SUBJECT: Contract 9160  
SR99, AWV-Replacement South Access SR99 Connections  
**CHANGE ORDER #022**  
**SR99 Roadway Settlement Repair**

CONTRACT NO: 009160 FEDERAL AID NO:  
CONTRACT TITLE: SR 99, ALASKAN WAY VIADUCT - REPLACEMENT SOUTH ACC  
CHANGE ORDER NO: 22 SR99 ROADWAY SETTLEMENT REPAIR

**DESCRIPTION OF WORK**

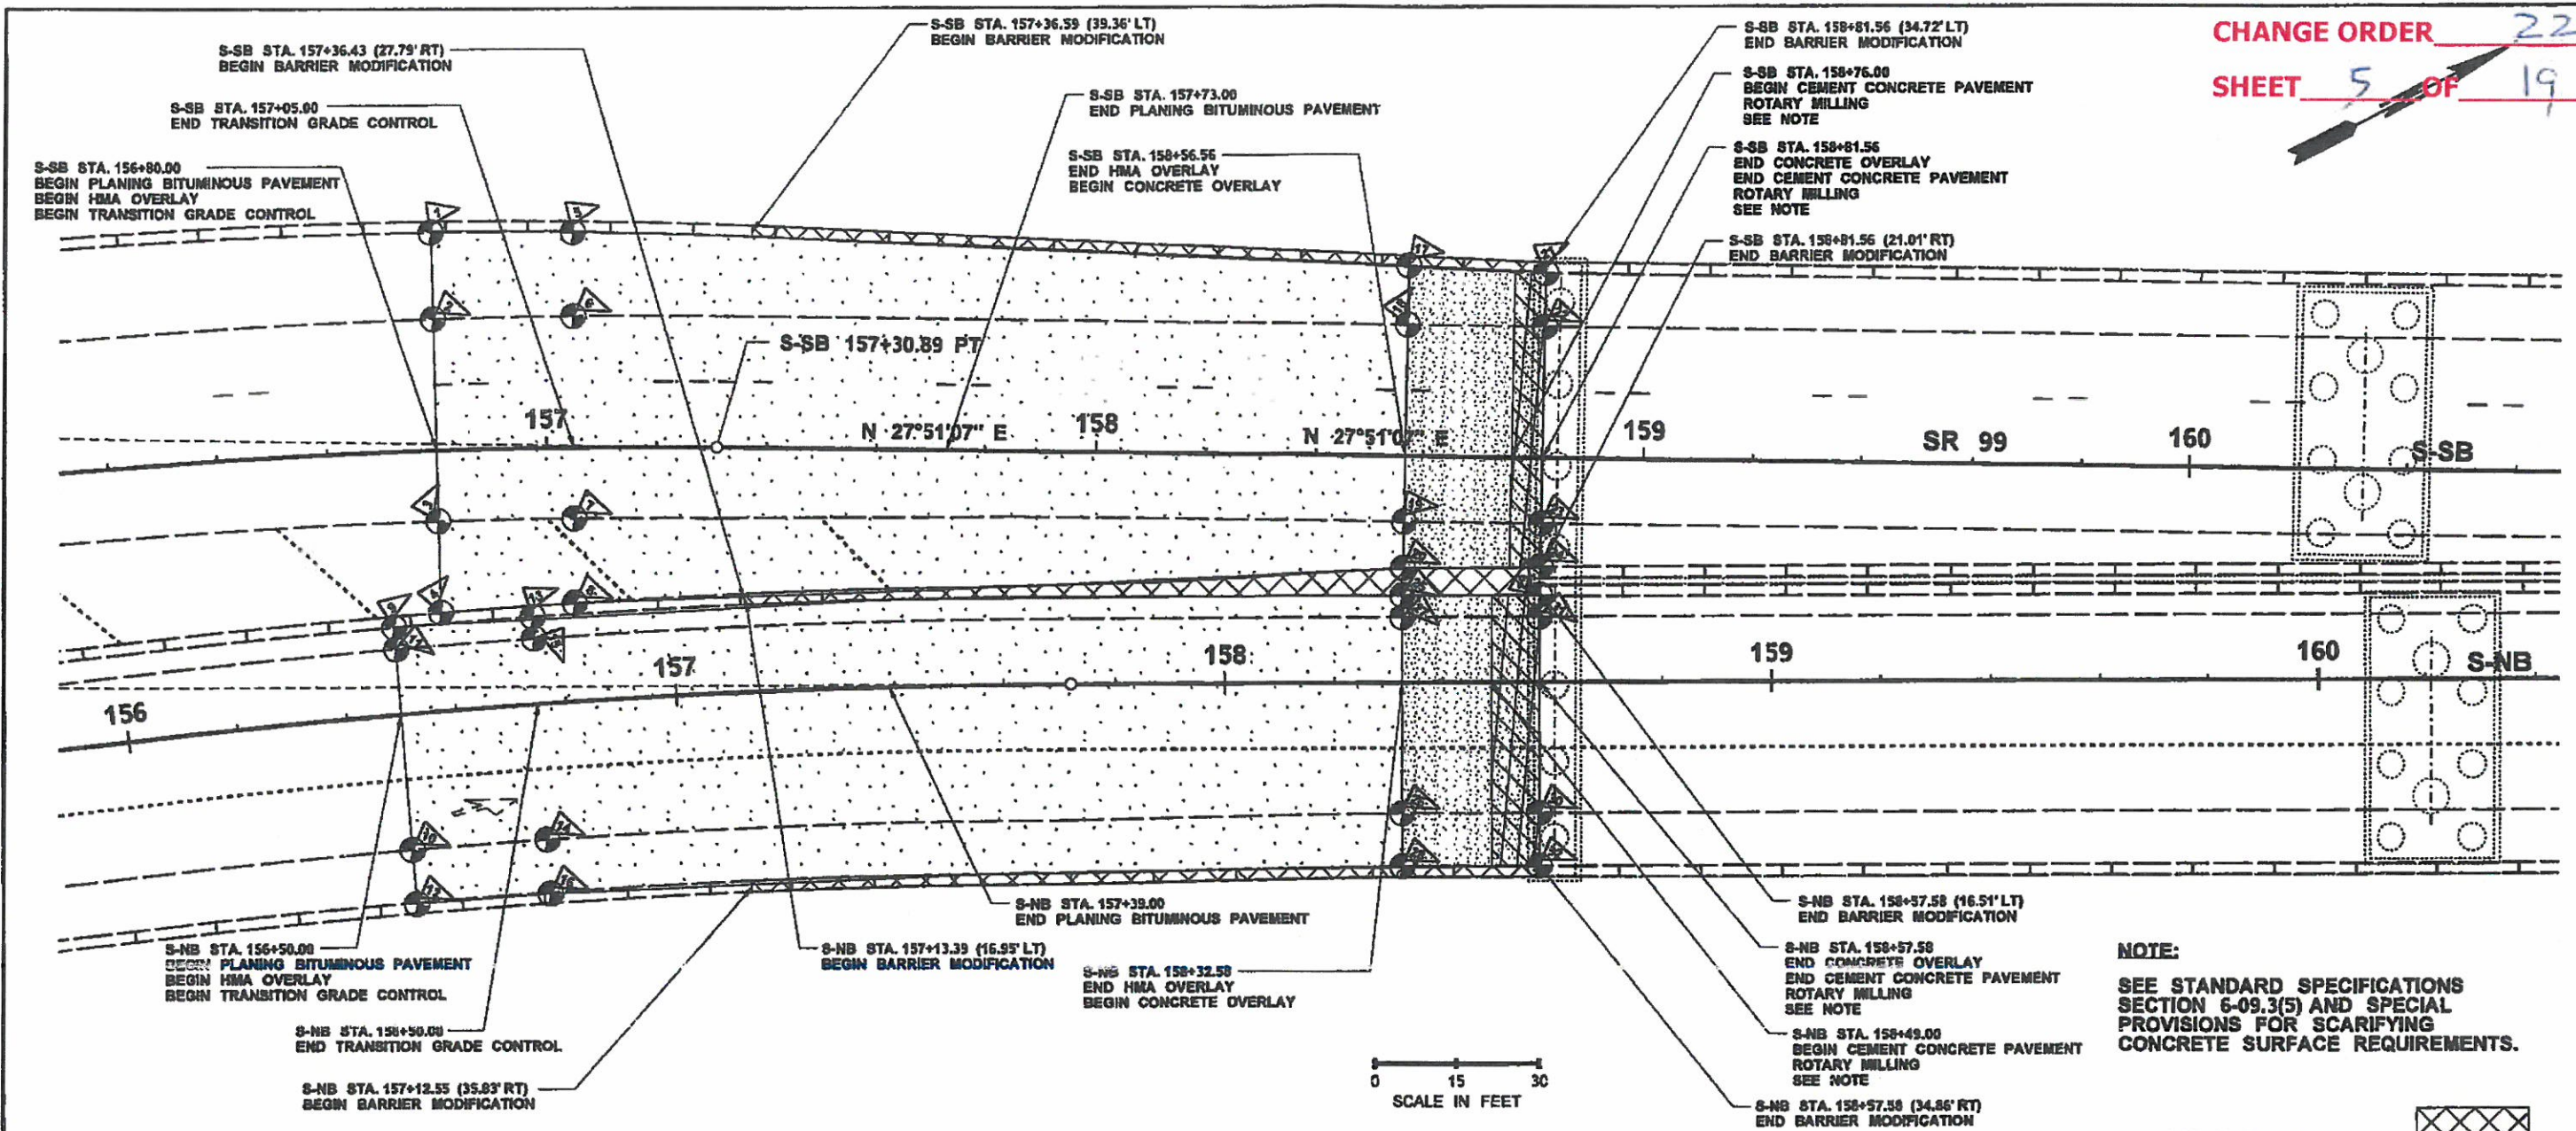
- (1) Adds planing Bituminous Pavement from S-SB 156+80 to S-SB 157+73 and S-NB 156+50 to S-NB 157+39.
- (2) Adds HMA Overlay from S-SB 156+80 to S-SB 158+56.56 and S-NB 156+50 to S-NB 158+32.58.

- (3) Performs rotary milling the existing concrete slab from S-SB 158+56.56 to S-SB 158+76 and S-NB 158+32.58 to S-NB 158+49.
- (4) Adds a concrete overlay to the existing concrete slab from S-SB 158+76 to S-SB 158+81.56 and S-NB 158+49 to S-NB 158+57.58 including installation of the steel reinforcement.

- (5) Modifies the barrier at the following locations:
  - S-SB 157+36.59 (39.36' LT) to S-SB 158+81.56 (34.72' LT)
  - S-SB 157+36.43 (27.29' RT) to S-SB 158+81.56 (21.01' RT)

- S-NB 157+13.39 (16.95' LT) to S-NB 158+57.58 (16.51' LT)
  - S-NB 157+12.55 (35.83' RT) to S-NB 158+57.58 (34.86' RT)
- (6) Implements the traffic control as shown in the plans. Adds temporary barrier and temporary striping to shift traffic in order to maintain access.

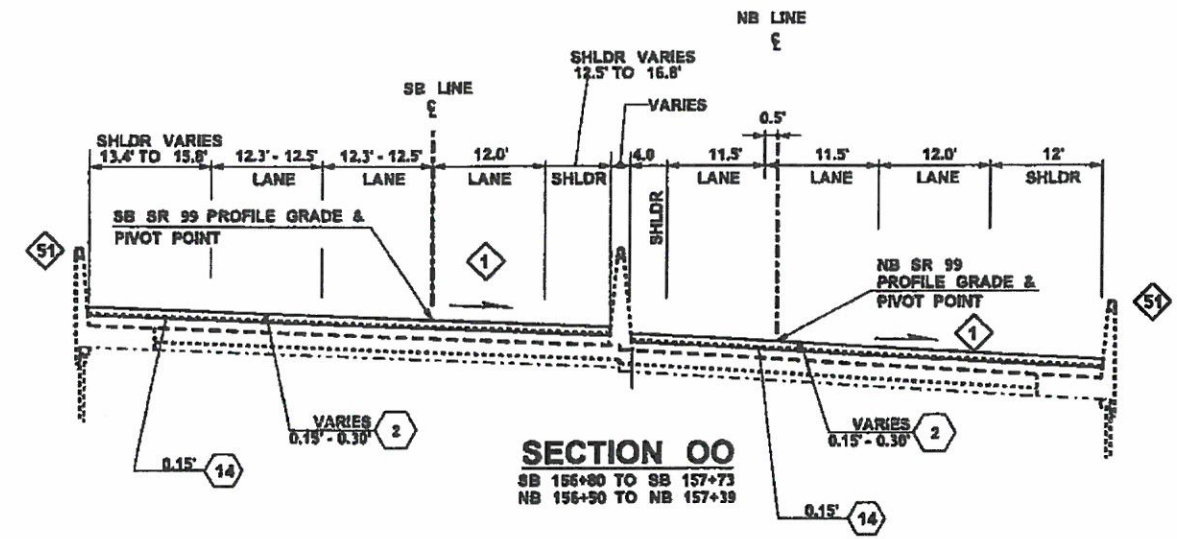
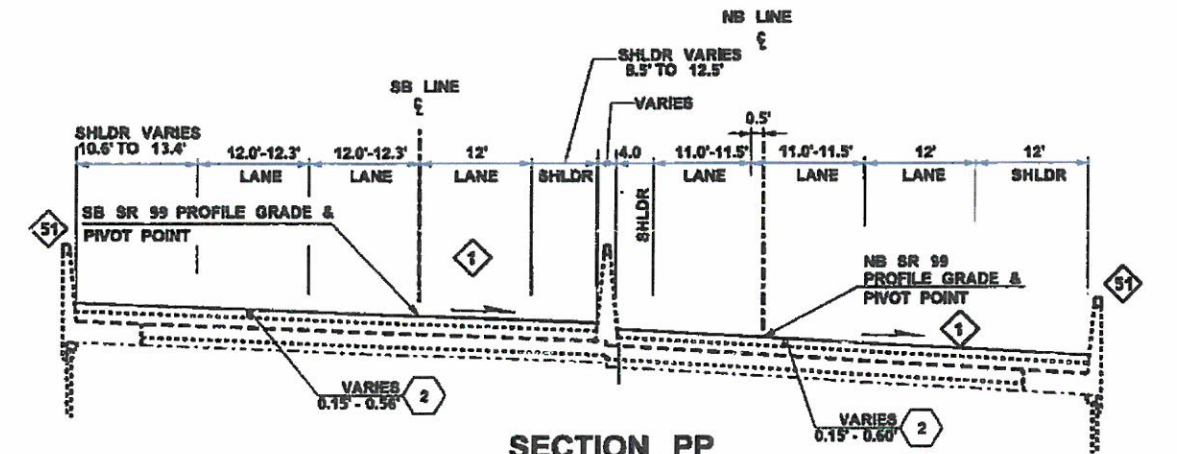
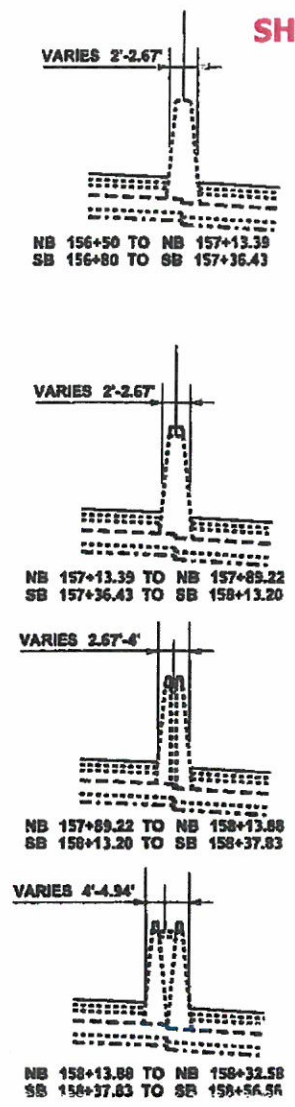
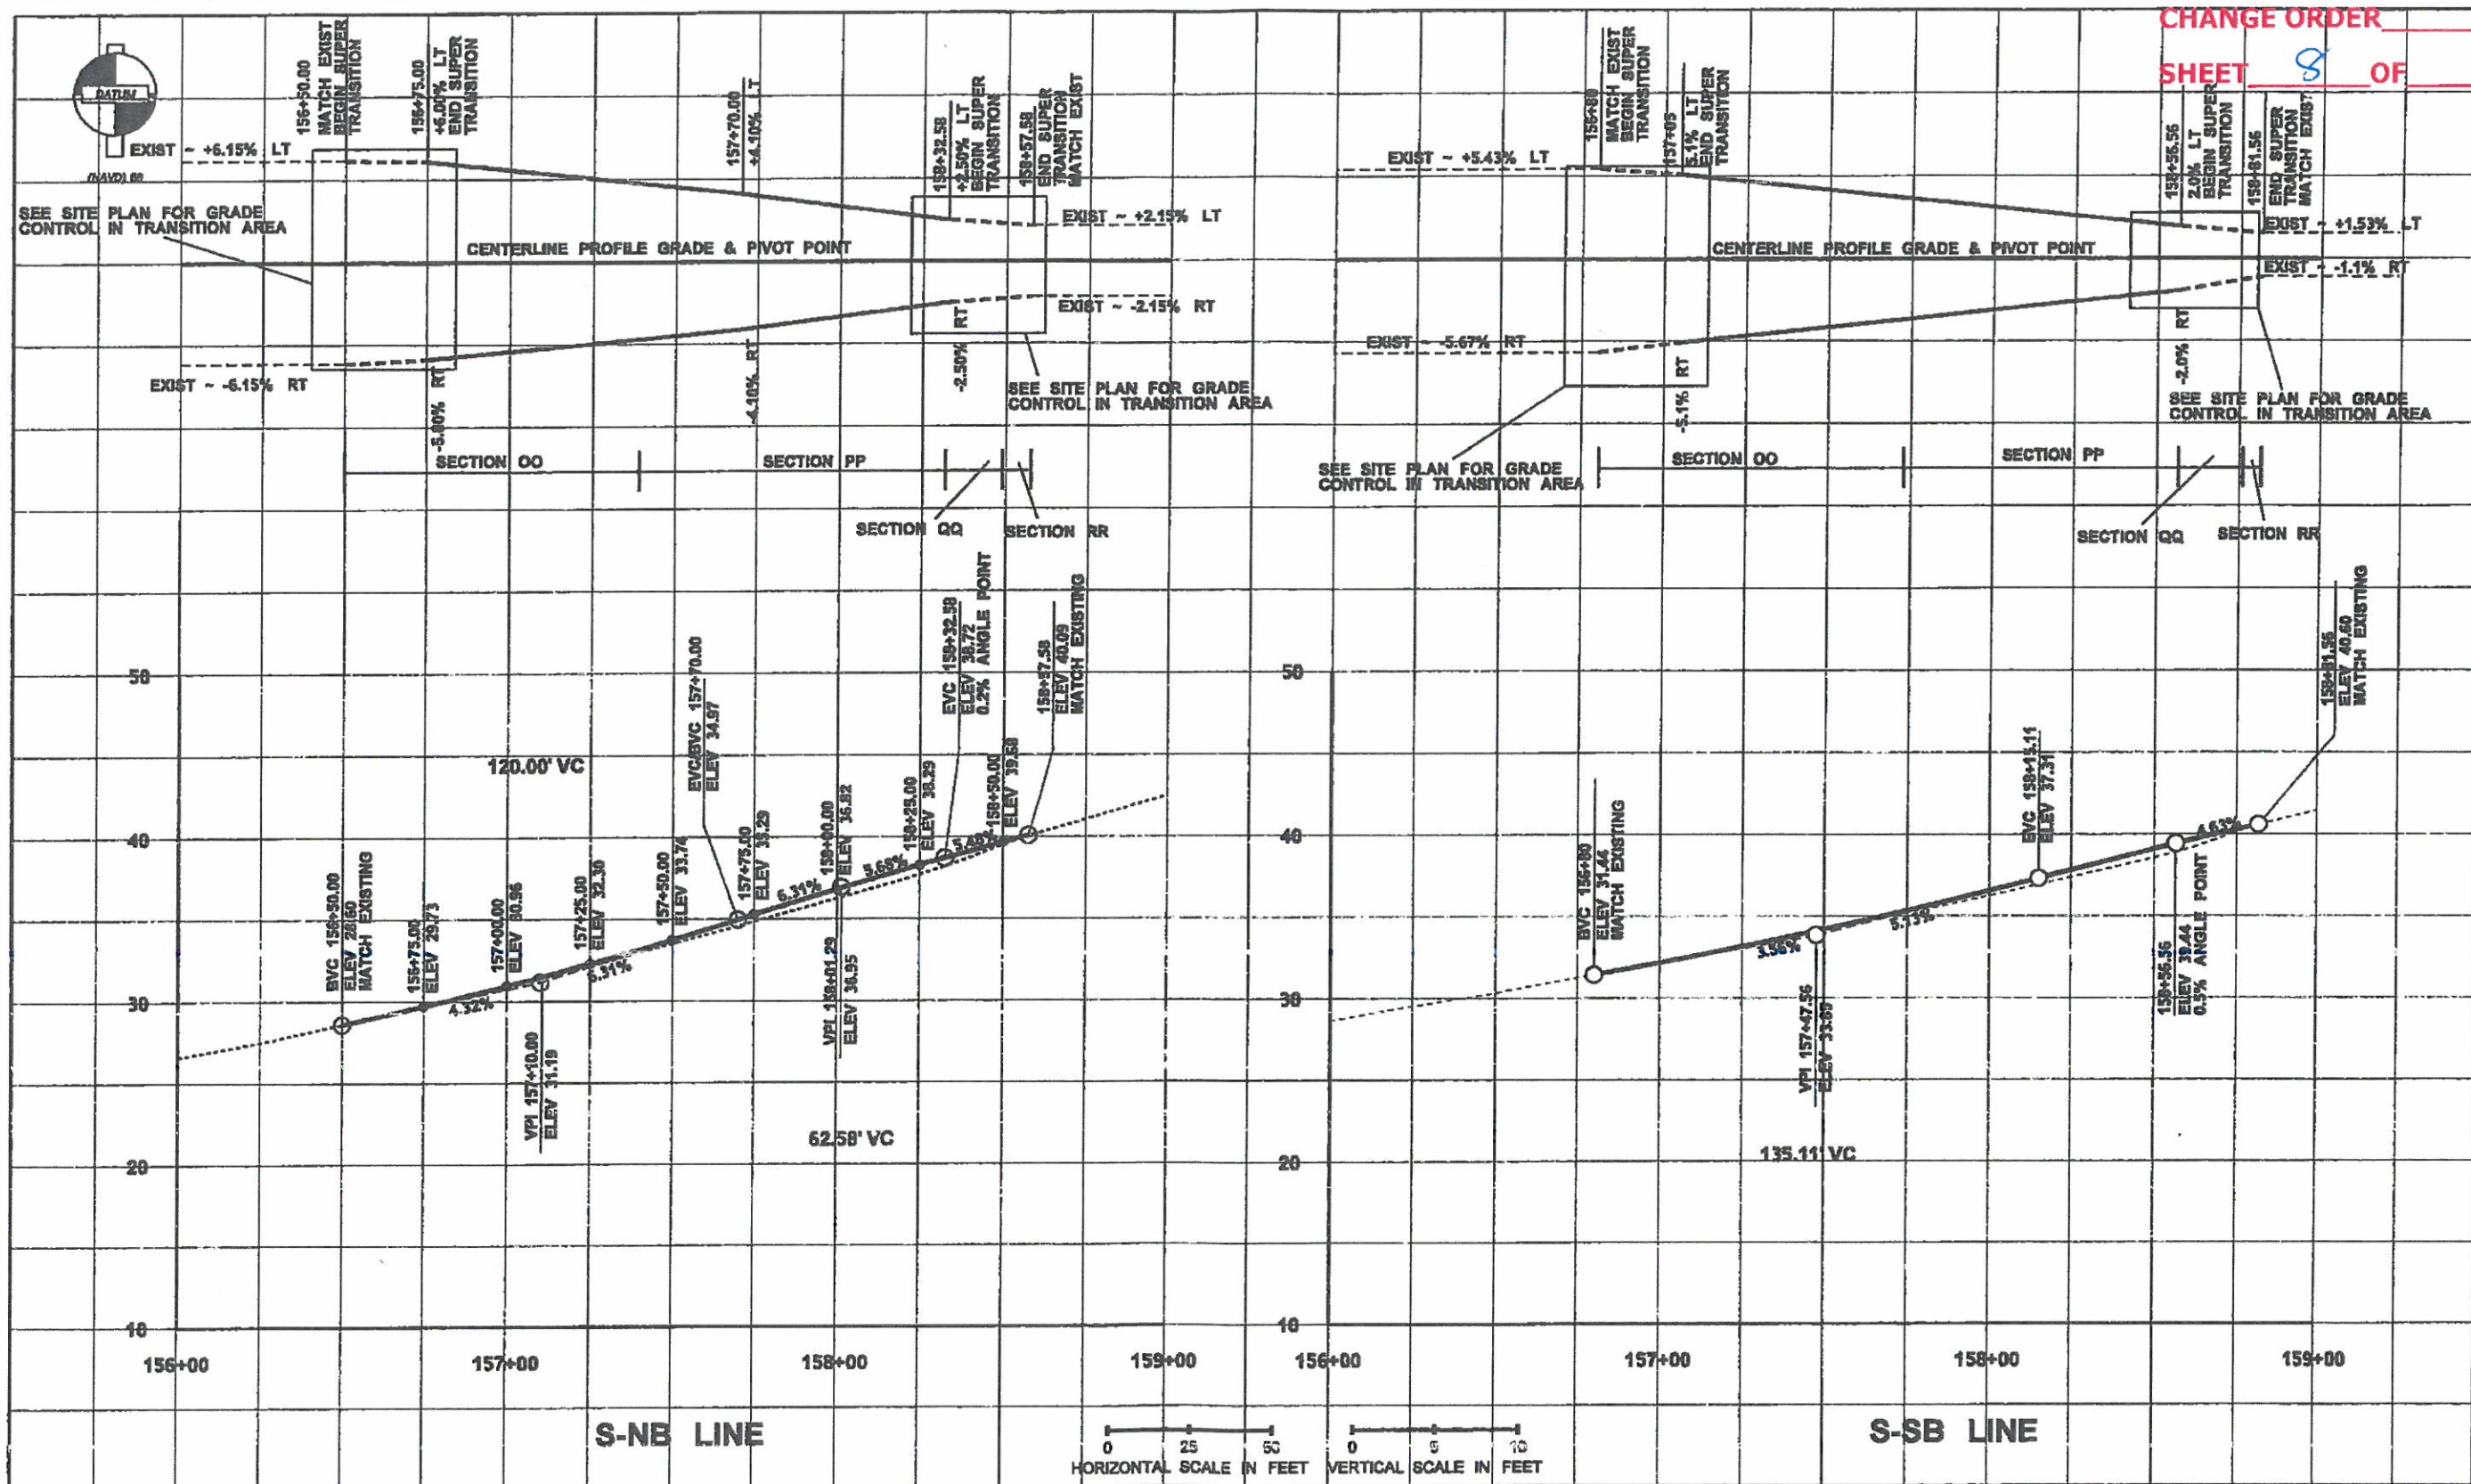
This change order revises the roadway profiles by overlaying the existing pavement to address settlement of Northbound and Southbound SR99 mainline and modifies the existing barrier as follows:
